Docket Number:	18-IRP-01
Project Title:	Integrated Resource Plan
TN #:	229608
Document Title:	Staff Paper - Review of Sacramento Municipal Utility District's 2018 Integrated Resource Plan
Description:	N/A
Filer:	Harinder Kaur
Organization:	California Energy Commission
Submitter Role:	Commission Staff
Submission Date:	8/29/2019 2:48:50 PM
Docketed Date:	8/29/2019

Review of Sacramento Municipal Utility District's 2018 Integrated Resource Plan

August 2019 | CEC-200-2019-014

Figure 1: SMUD and CEC Energy Forecasts 2018 to 2030 (GWh)

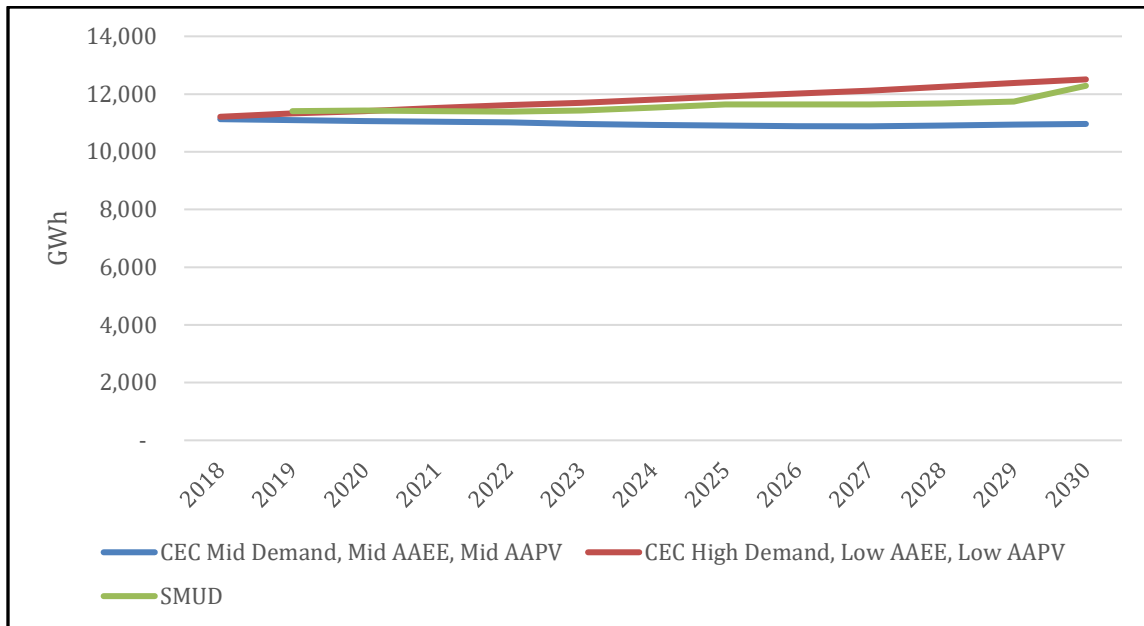
As shown in **Figure 1**, SMUD’s demand forecast is between the CEC’s 2018 Mid Demand, Mid AAEE, Mid AAPV IEPR demand forecast and the 2018 High Demand, Low AAEE, Low AAPV IEPR demand forecast.⁷ SMUD expects slow growth in its energy demand over the forecast period. Growth in EV numbers and building electrification will increase energy demand, but that is expected to be offset to some extent by slow growth in housing stock and business activity, along with increases in customer-sited solar and battery storage. SMUD’s energy demand is forecast to increase from 11,404 GWh in 2019 to 12,296 GWh in 2030.

Figure 2: SMUD and CEC Peak Forecasts 2018 to 2030 (GWh)

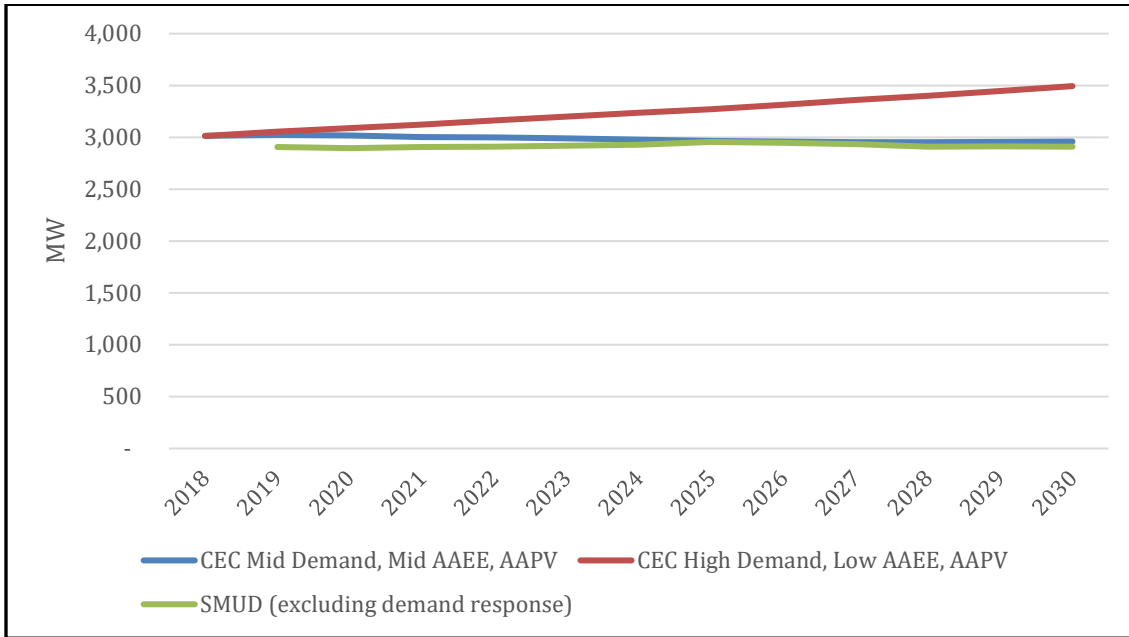
As shown in **Figure 2**, SMUD’s peak load forecast is slightly lower than both of the CEC’s peak load forecasts. In contrast to SMUD’s energy demand forecast, SMUD’s peak load is forecast to be flat through 2030. More widespread implementation of TOD rates is a key factor that will contribute to keeping SMUD’s peak load flat through the forecast period.

Figure 3: Sources of Renewables Portfolio Standard Eligible Energy 2019 to 2030 (MWh)

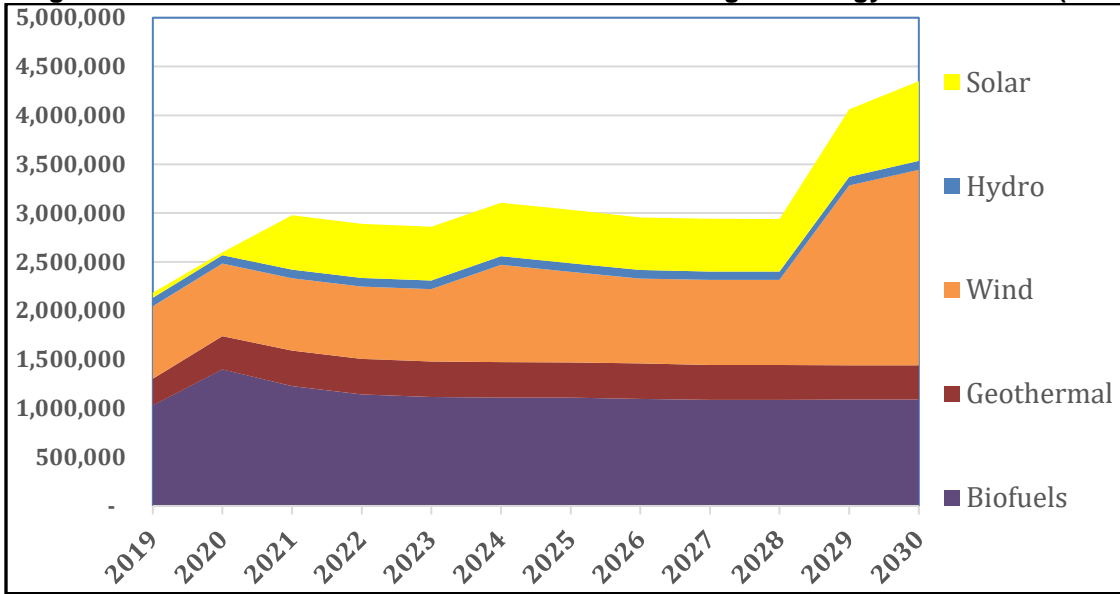
Figure 3 shows the total energy procured from each renewable energy technology type from 2019-2030.

These figures illustrate that wind and solar energy procurement will increase significantly while other sources of renewable energy will remain relatively flat through the forecast period. Because of the large growth in solar and wind, the other renewable technology types will decrease in percentage terms of SMUD’s renewable energy sources.

Figure 4: SMUD Renewables Portfolio Standard Resource Mix in 2019 to 2030

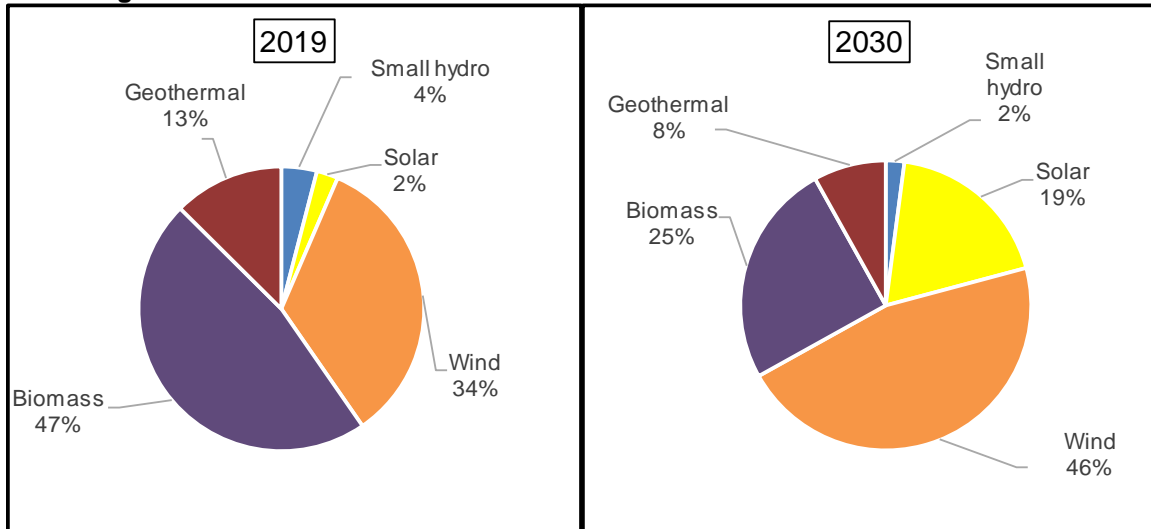
Figure 4 shows the percentage of renewable energy by technology in 2019 and 2030.

Figure 5: SMUD Portfolio Comparison for 2019 and 2030

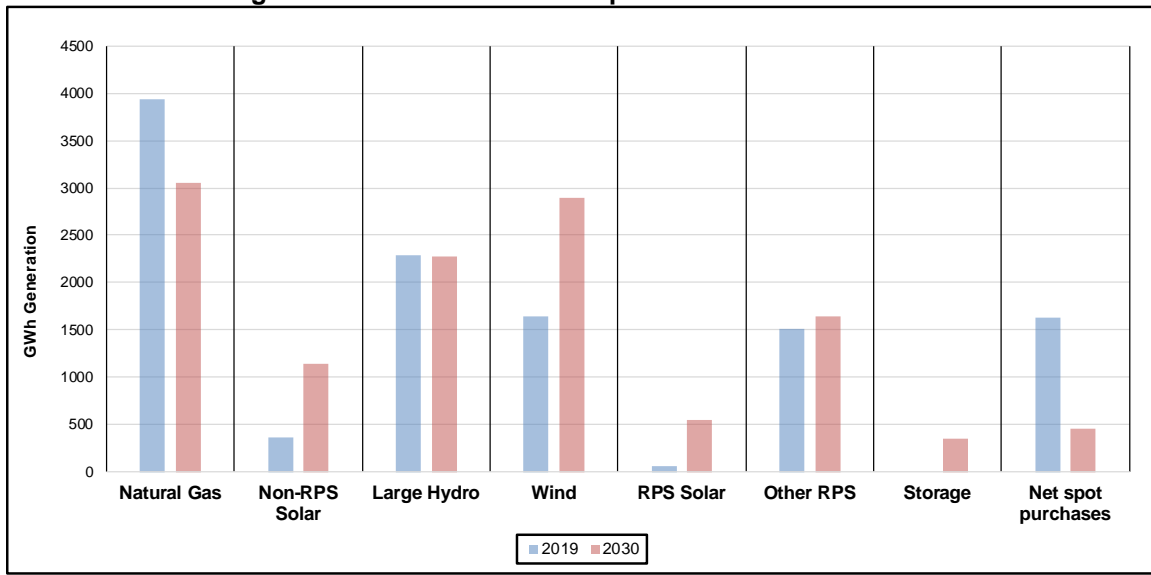
SMUD’s current resource portfolio is very diverse, with a mix of fossil fuel and renewable resources. Natural gas, hydroelectric, solar, and wind are all significant portions of SMUD’s current resource mix. SMUD analyzed several resource portfolio options and selected the one that would allow it to meet State requirements while limiting cost increases. SMUD does not expect to need additional fossil fuel resources over the forecast period. In order to meet GHG reduction and RPS goals, SMUD is planning to procure additional wind, solar, and energy storage resources. **Figure 5** shows a comparison of the energy mix by resource in SMUD’s preferred portfolio in 2019 and 2030.
